Metropolitan Planning Commission

Staff Reports

Tuesday, October 14, 2008

2008SP-027U-14

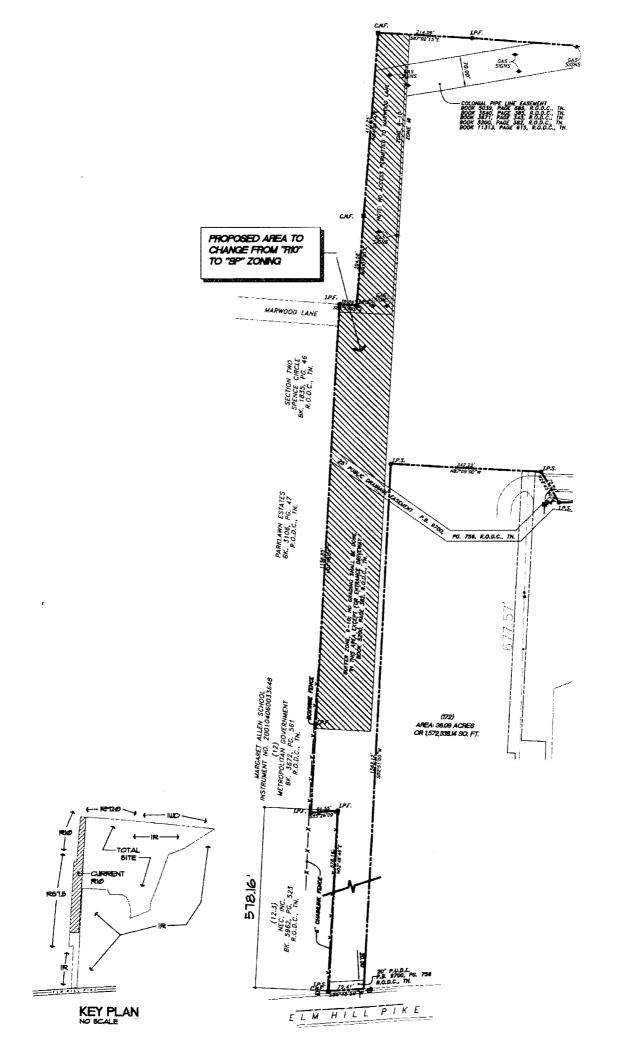
The site plan proposes a 1,470 foot driveway and a 30 foot landscape buffer. The proposed drive will run north of Elm Hill Pike adjacent to a landscape buffer along the eastern property line of the site. The driveway will turn west approximately 297 feet south of Marwood Lane. No access is shown on to Marwood Lane from the proposed driveway and none will be permitted. The plan includes security lighting along the driveway and a security gate at the entrance along Elm Hill Pike.

A 30 foot landscape buffer along the eastern property line of the site is proposed. The existing vegetation is approximately 80 feet in width. Staff is requiring that the applicant provide a minimum 50 foot landscape buffer along the eastern property line of the site in order to provide adequate separation between the existing residential and industrial uses. The landscape plan includes trees to be planted 50 feet center to center along one side of the access road and a provision to allow additional planting to meet the landscaping requirements of the Metro Code. A tree protection fence is to be in place during construction of the driveway to protect the existing vegetation that is to be part of the landscape buffer.

Provide documentation of adequate sight distance at project access to Elm Hill Pike.

- 1. There shall be no access to Marwood Lane.
- 2. The corrected copy of the SP final site plan shall incorporate the required landscape buffer abutting the adjacent residential with a minimum of 50 feet in width
- 3. The corrected copy of the SP final site plan shall include a note stating that a tree protection fence shall be in place during the construction of the driveway to protect the existing vegetation that is to be part of the landscape buffer.
- 4. The permitted uses for this SP shall include a private driveway and a minimum 50 foot landscape buffer.
- 5. For any development standards, regulations and requirements not specifically shown on the SP plan and/or included as a condition of Commission or Council approval, the property shall be subject to the standards, regulations and requirements of the IR zoning district as of the date of the applicable request or application.

2008S-155G-04

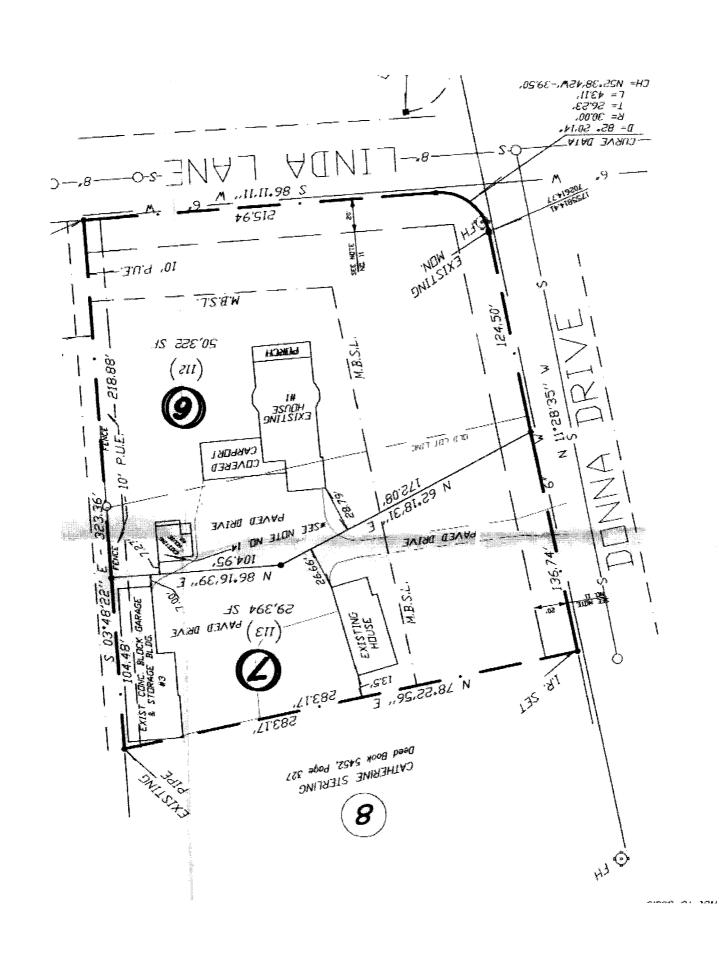
- Lot 6: 50,322 sq. ft. with approximately 236 linear ft. of frontage on Linda Lane, and 125 linear ft. of frontage on Donna Drive
- Lot 7: 29,394 sq. ft. with approximately 137 linear ft. of frontage. Lot 7 fails for area by 45 square feet.

The applicant is requesting a variance to the lot line requirements of Section 3-4.2 (a) of the Subdivision Regulations. The regulations require the residential side lot lines be at right angles to street lines unless a variation from this rule will give a better street or lot plan. The new lot line, which intersects Donna Drive, does not form a right angle with the street. However, it does correct the original lot line, which was platted

showing a portion of the existing house on Lot 6 and its accessory use on Lot 7. The new lot line provides a better lot layout for each lot and more clearly delineates the lot boundaries.

Staff recommends approval of the final plat and granting a variance to lot line requirements of Section 3-4.2 (a) of the Metro Subdivision Regulations and an exception to lot comparability.

2008S-156U-07

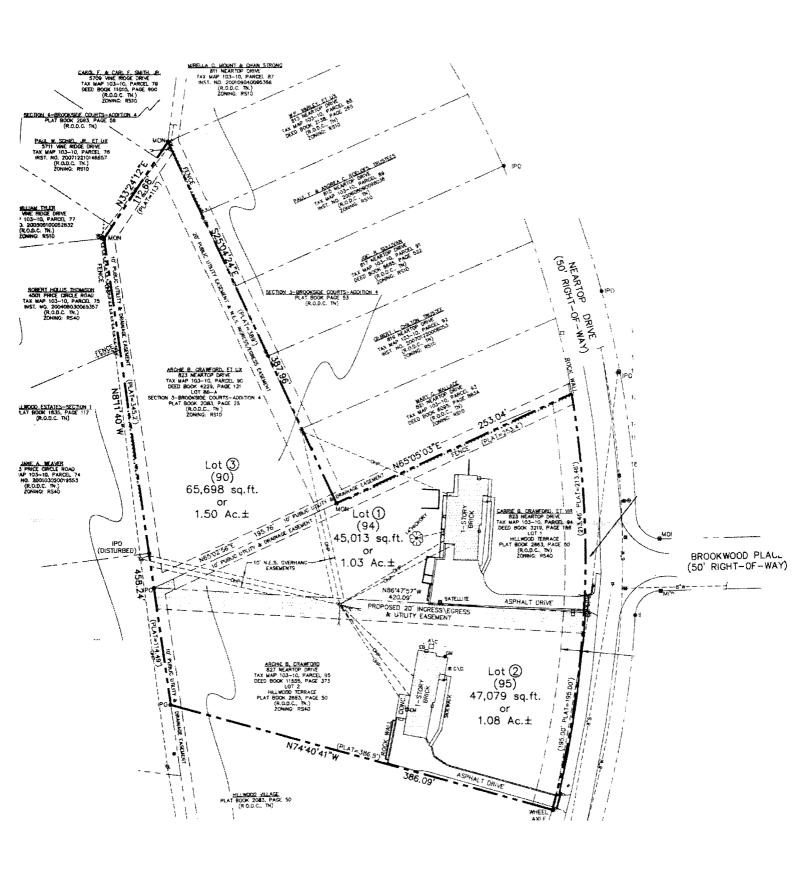
The purpose of this request is to remove the reserve parcel status on a parcel in order to create a buildable lot. This lot, shown as Lot 3 on the plat would not have street frontage. The request also includes an access easement through Lot 1 to serve Lot 3. In order to satisfy the requirements of the Fire Marshal, a 100 foot diameter turnaround is proposed at the end of the easement as the easement exceeds 150 feet in length.

The original plat does not indicate why Lot 3 was designated as a reserve parcel rather than incorporated into adjacent lots at the time of the initial subdivision. As all other lots in this area have street frontage, development on this parcel would not be in character with the pattern of development in the area.

PUBLIC WORKS RECOMMENDATION	No exception taken.
STORMWATER RECOMMENDATION	Approved
WATER SERVICES RECOMMENDATION	Approved
FIRE MARSHAL RECOMMENDATION	 Conditional Approval Access to each property shall be from a public access way or property controlled by the property owner w/out crossing other property owner's property lines to reach the property unless an easement is in place. Any easement that is part of a Fire Lane must be deeded as a perpetual on going self renewing document w/ no termination. One & two family final plat plans must show result from fire hydrant(s) flow test, performed within 6 months with a minimum of 1000 gpm @ 20 psi available at hydrants, for buildings up to 3600sq. ft. to be approved for fire hydrant flow requirement Fire department access roads shall be provided such that any portion of the facility or any portion of an exterior wall of the first story of the building is located not more than 150 ft (46 m) from fire department access roads A fire department access road shall extend to within 50 ft of at least one exterior door that can be opened from the outside and that provides access to the interior of the building. All dead end roads over 150 ft. in length require a 100 ft. diameter turnaround, this includes temporar turnarounds. Temporary T-type turnarounds that last no more than one year shall be approved by the Fire Marshal's Office. Fire Hydrants shall be in-service before any combustible material is brought on site. All fire department access roads shall be 20 feet minimum width and shall have an unobstructed vertical clearance of 13.6 ft. No part of any building shall be more than 500 ft

from a fire hydrant via an approved hard surface road. Metro Ordinance 095-1541 Sec: 1568.020 B

Staff recommends disapproval of the request to remove the reserve parcel status from Lot 3 and the request for a variance to street frontage for this lot because development on a lot without street frontage would not be in character with the pattern of development in the area.
